ADDENDUM NUMBER 2

PROJECT: **Ke-nek Water Treatment Plant and Water Main**

PROJECT NUMBER: **CA 21-F05**

OWNER: **Yurok Tribe**

KE-NEK WATER TREATMENT PLANT
AND KE-NEK WATER MAIN
PLAN & PROFILE, ACCESS ROAD

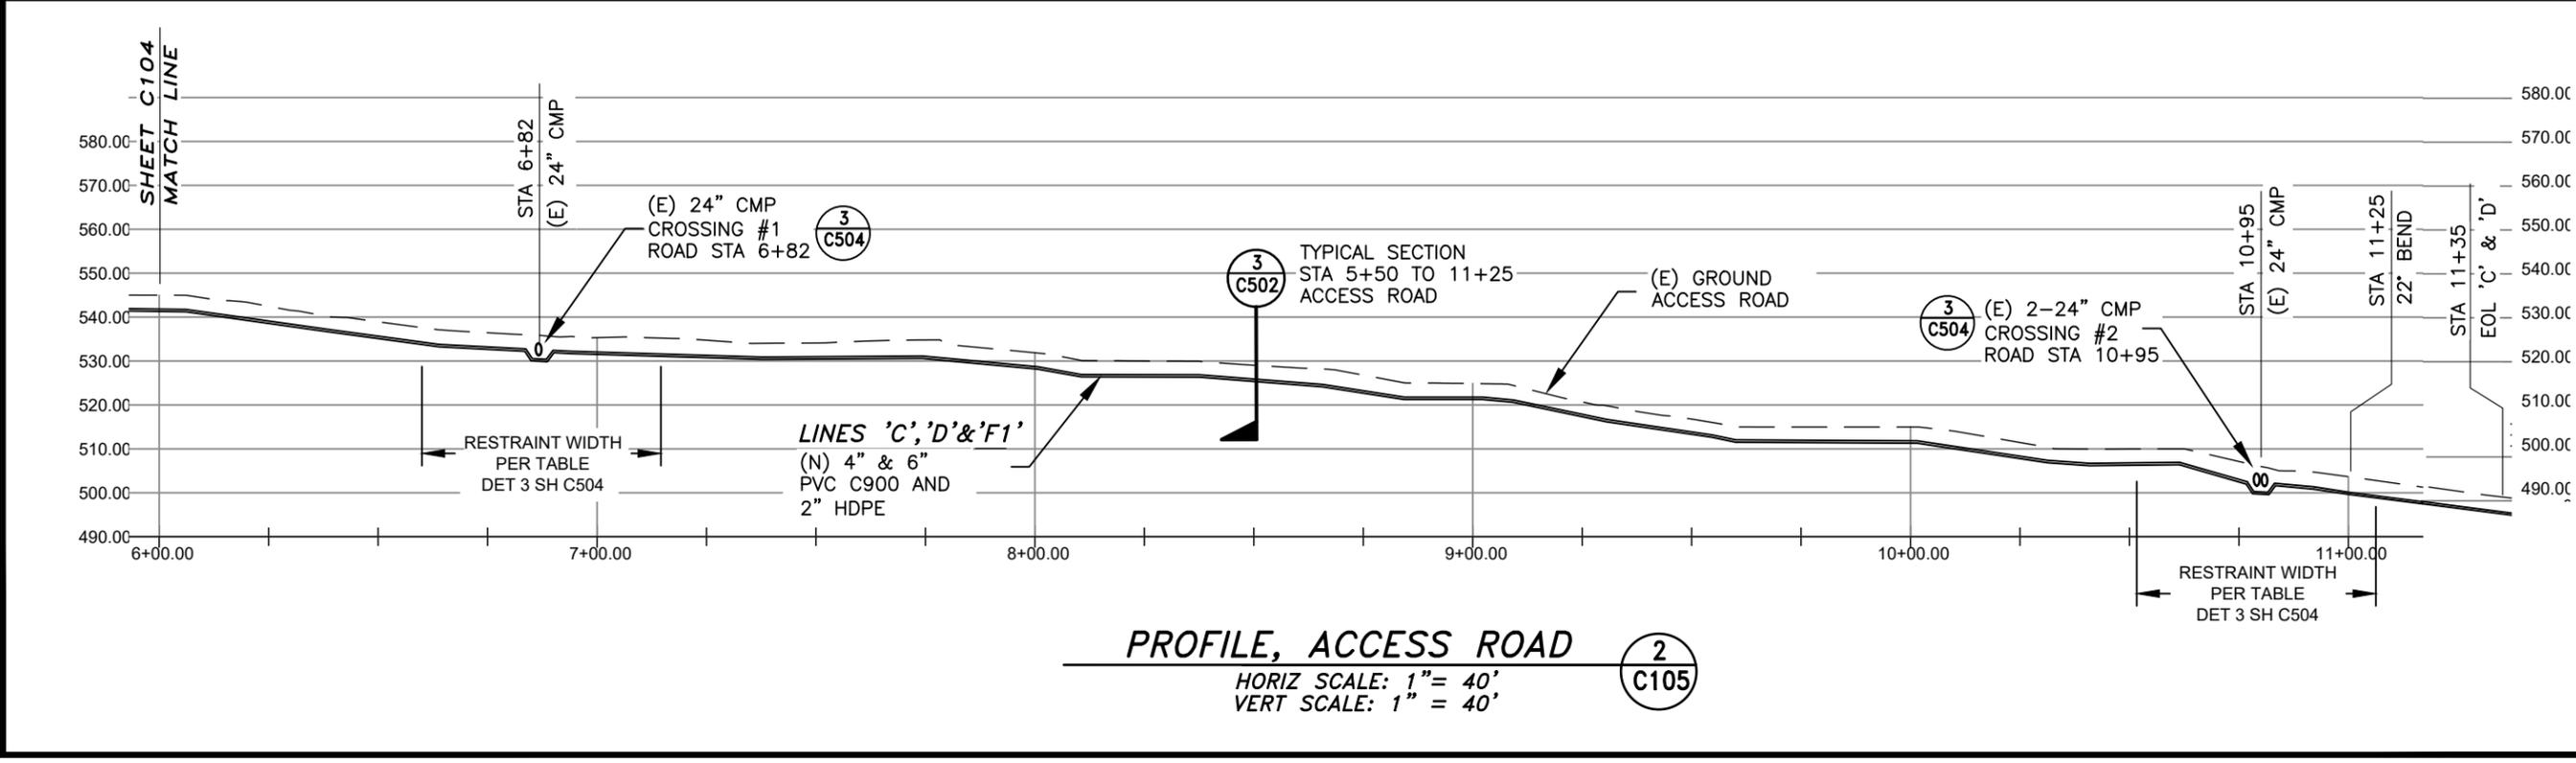
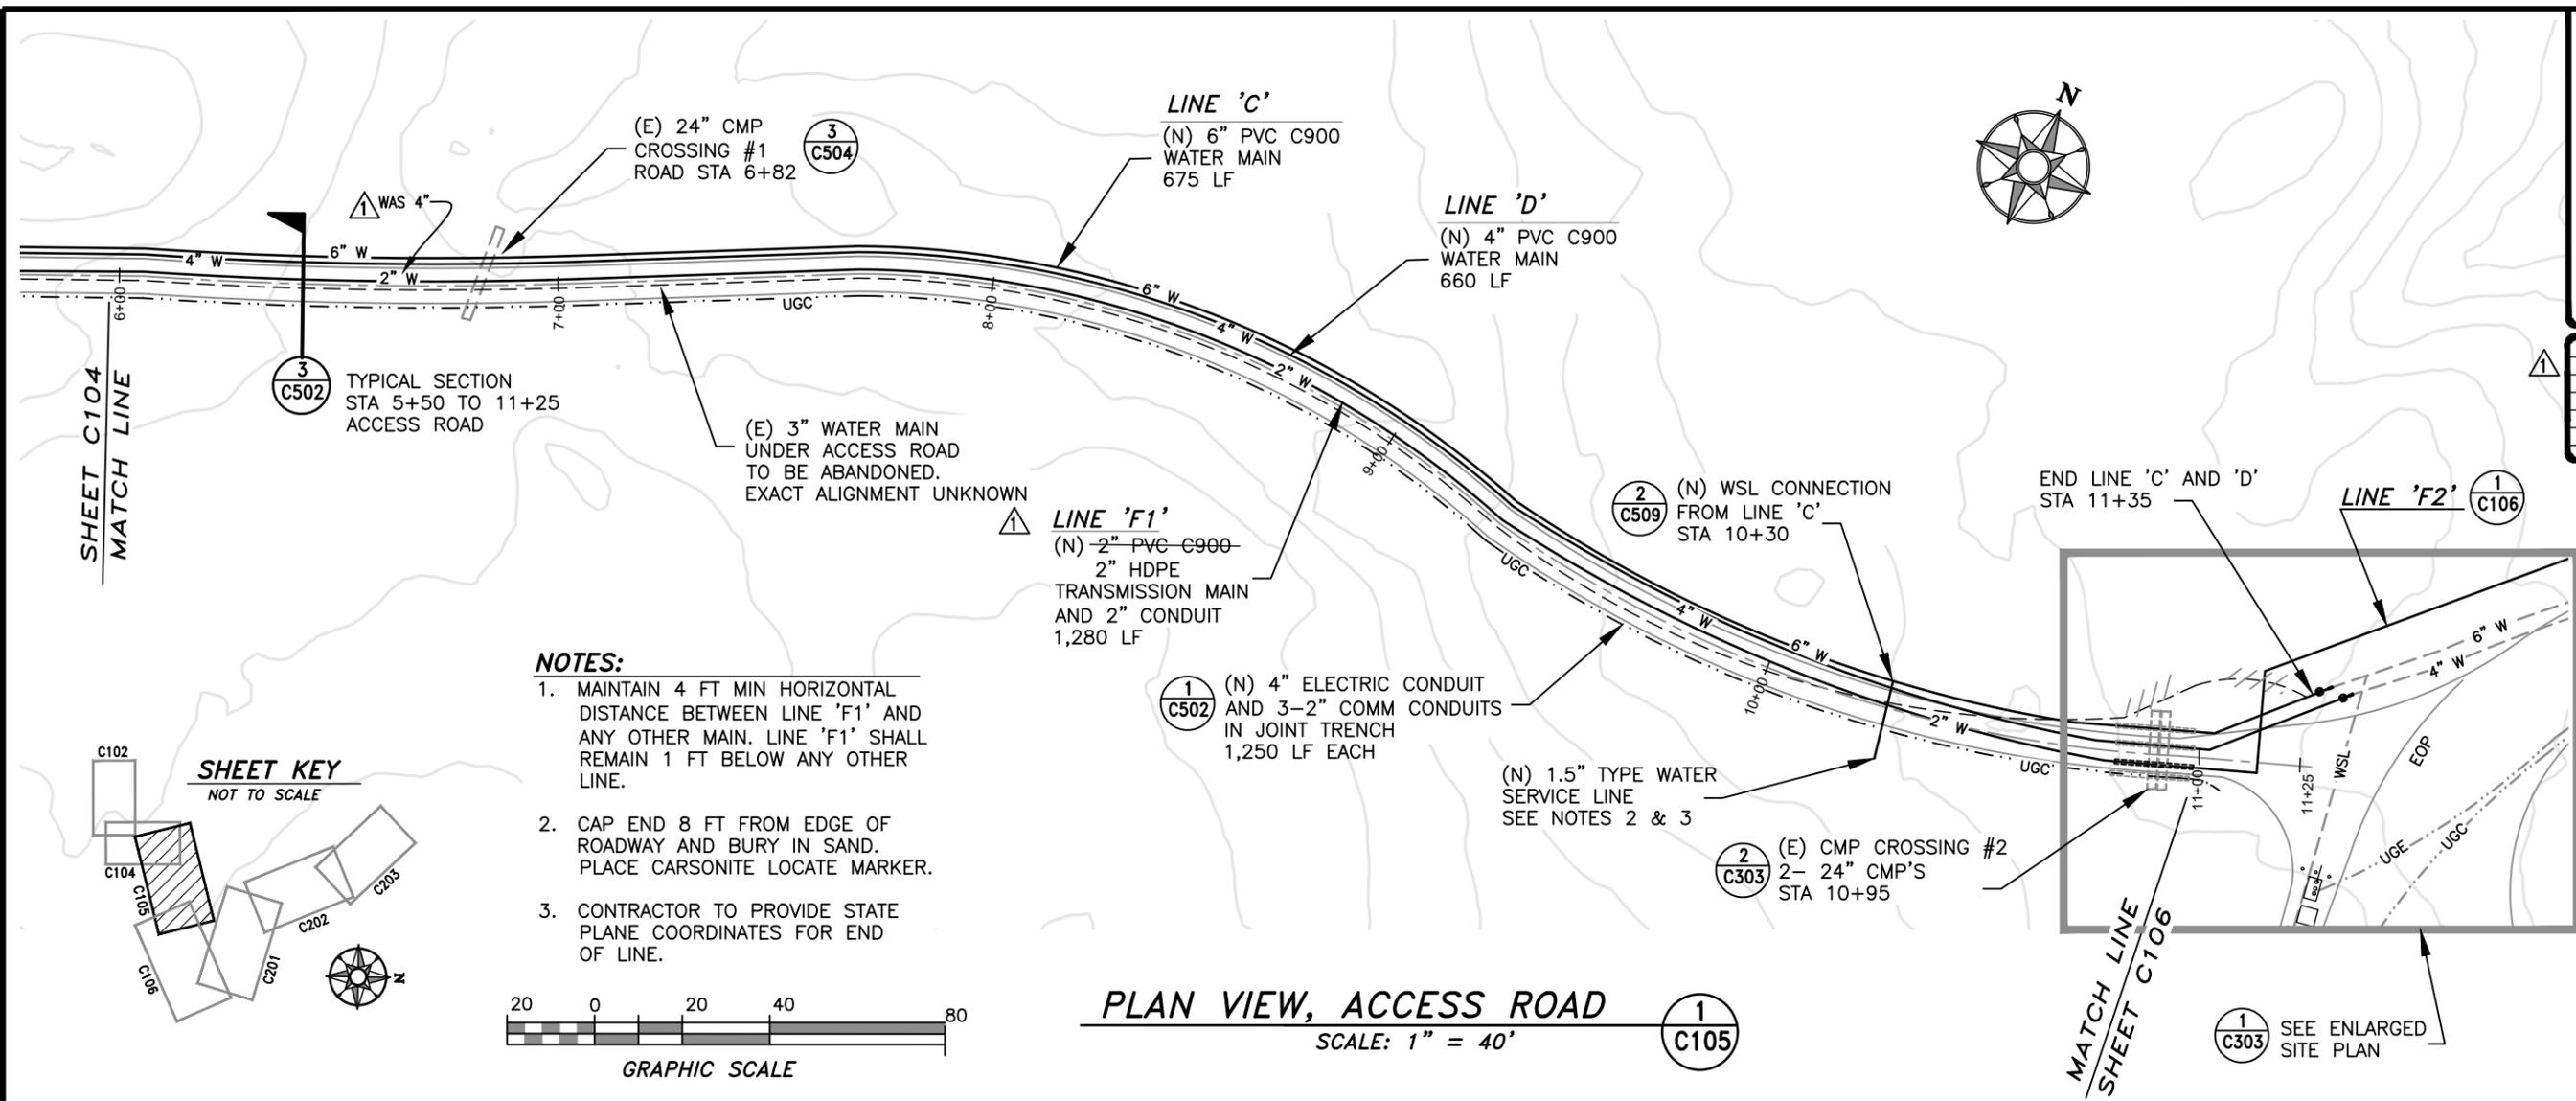
DRAWING C105 – Plan & Profile, Access Road

Linetype correction to line F1 (Label on line noted 4”, is now 2”)

Line F1 – 2” PVC C900 to 2” HDPE, 2 places

KE-NEK WATER TREATMENT PLANT
AND KE-NEK WATER MAIN
PLAN & PROFILE, TULLEY CREEK RD

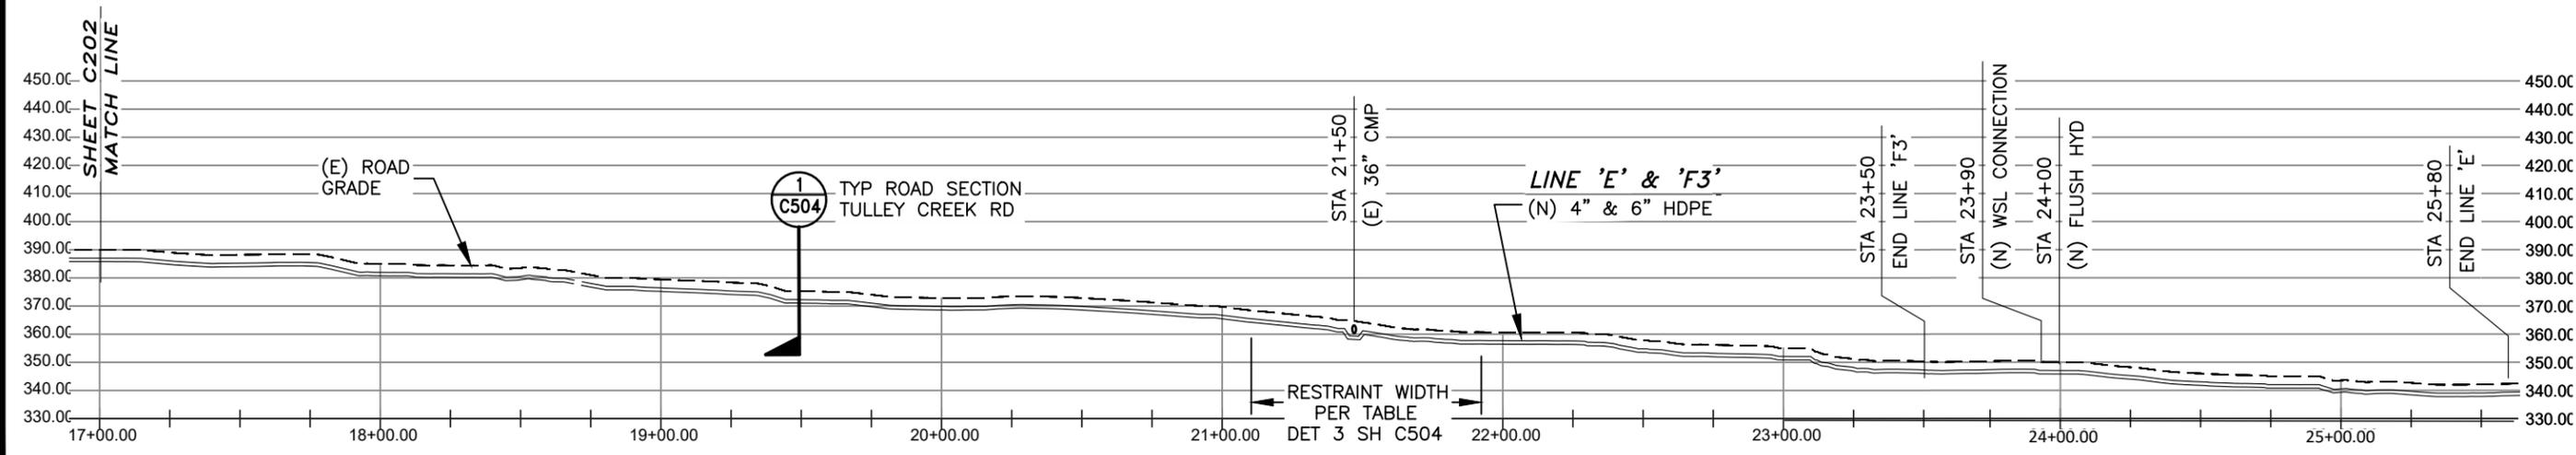
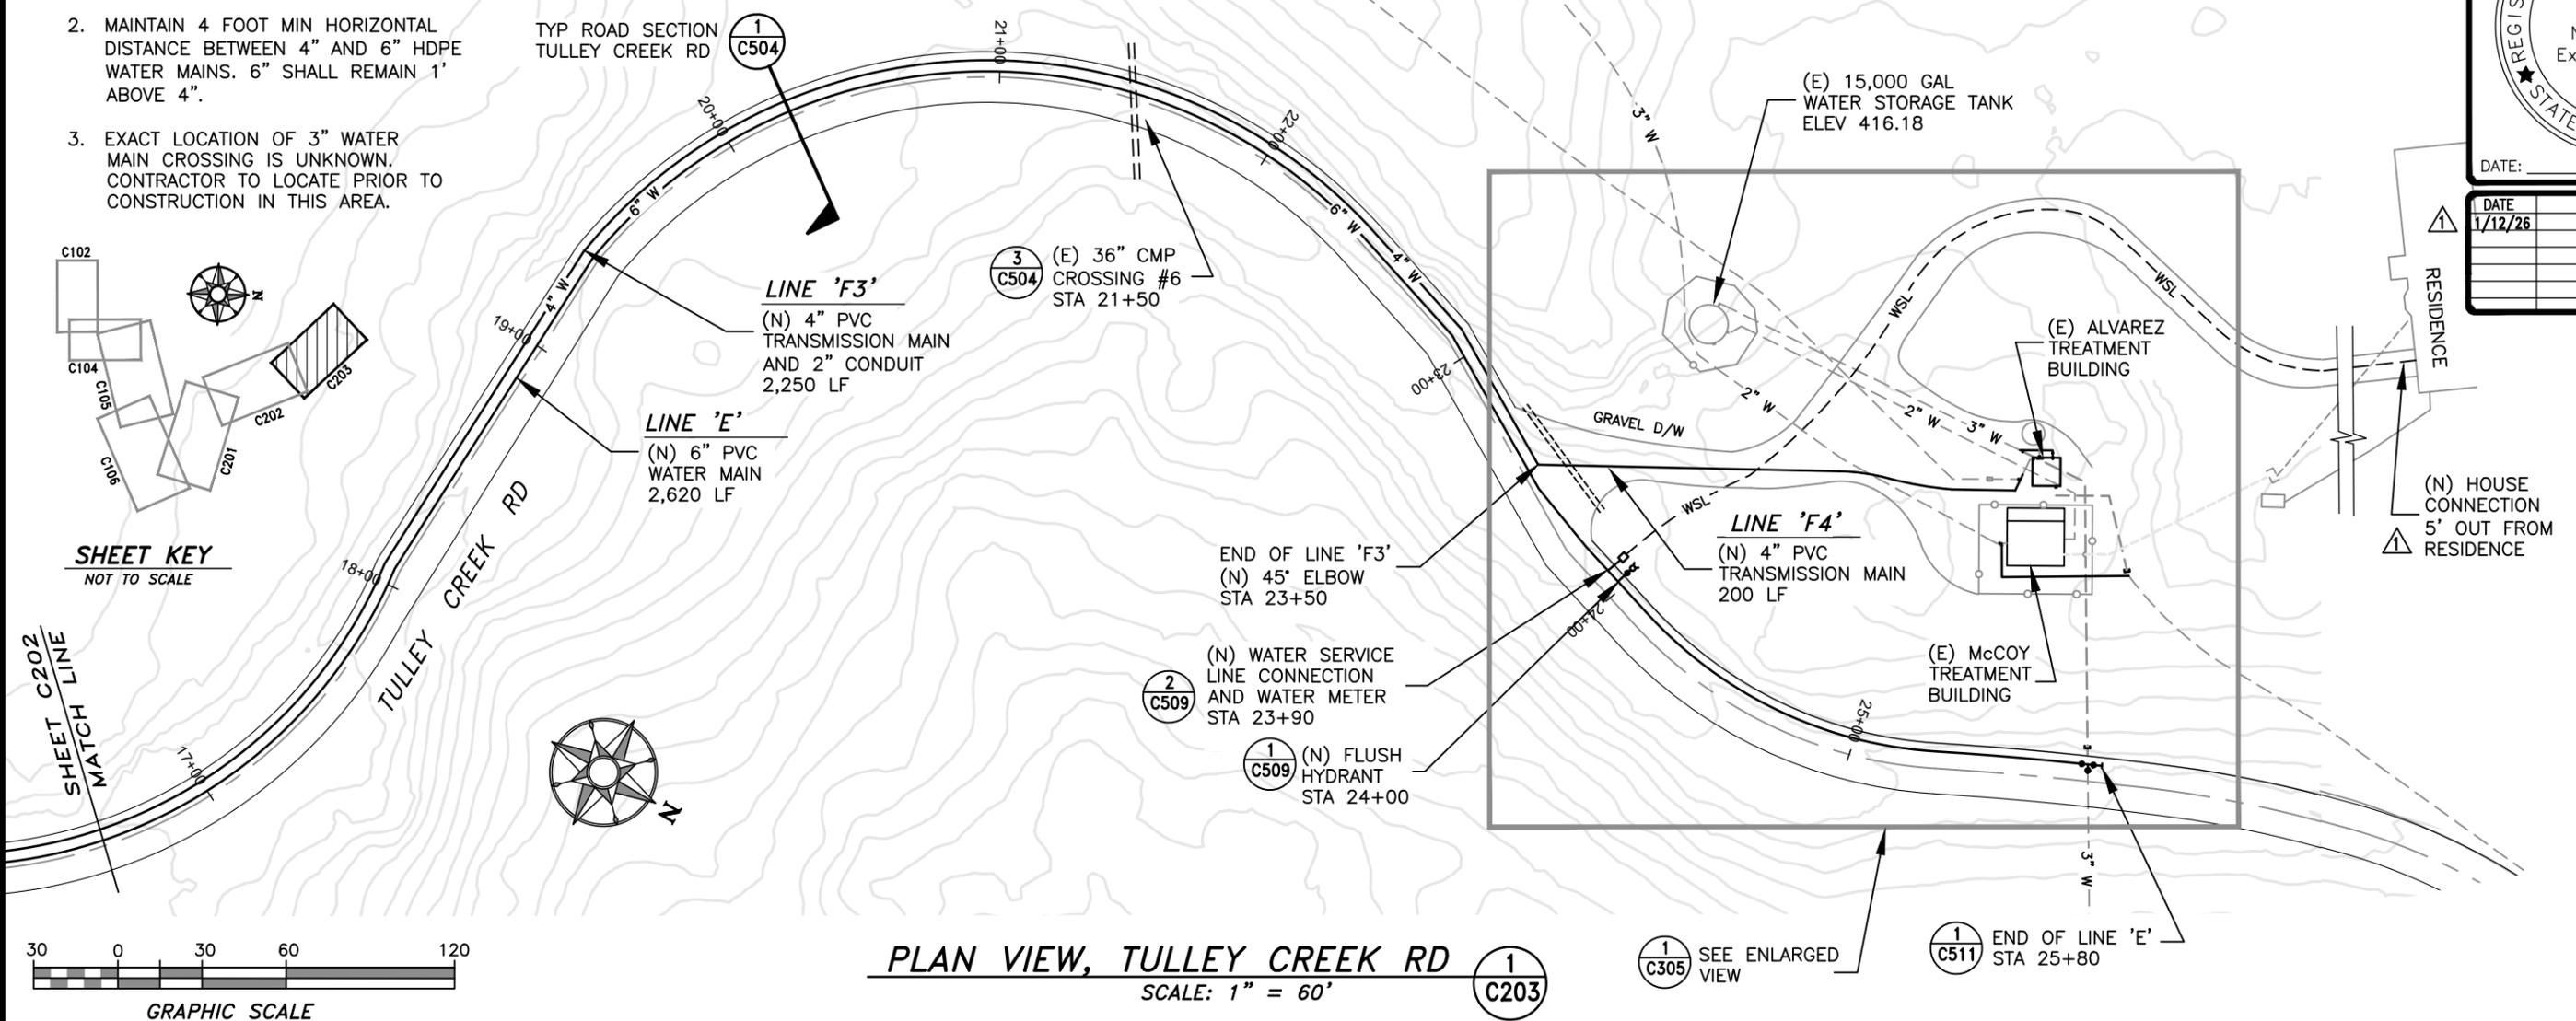
DRAWING C203 – Plan & Profile, Tulley Creek Road

WSL connection to home shown in more detail

KE-NEK WATER TREATMENT PLANT
AND KE-NEK WATER MAIN
ENLARGED SITE PLAN, TULLEY CREEK RD

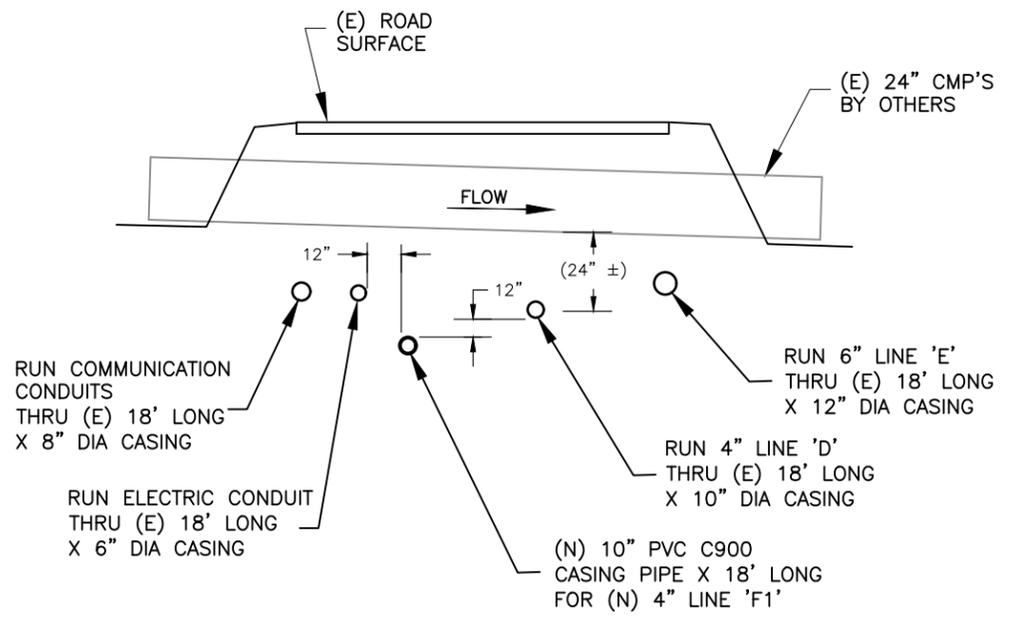
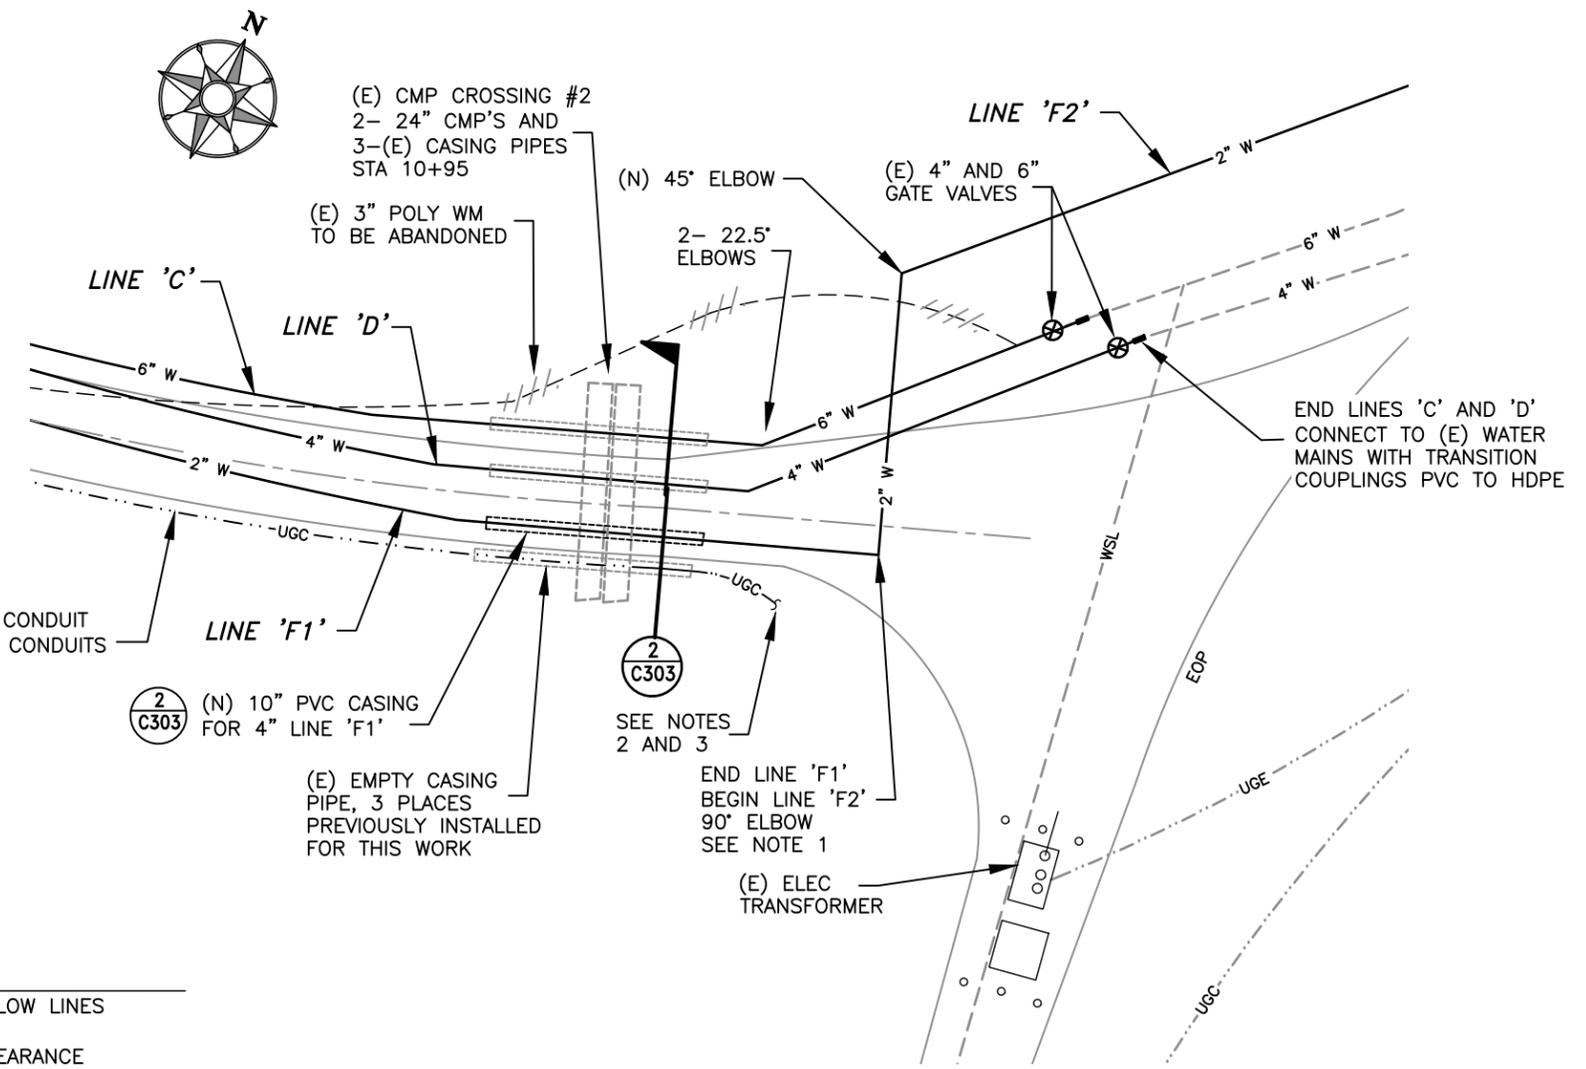
DRAWING C303 – Enlarged Site Plan, Tulley Creek Road

Detail is not to scale. Corrected to “Not to Scale” from 1” = 40’
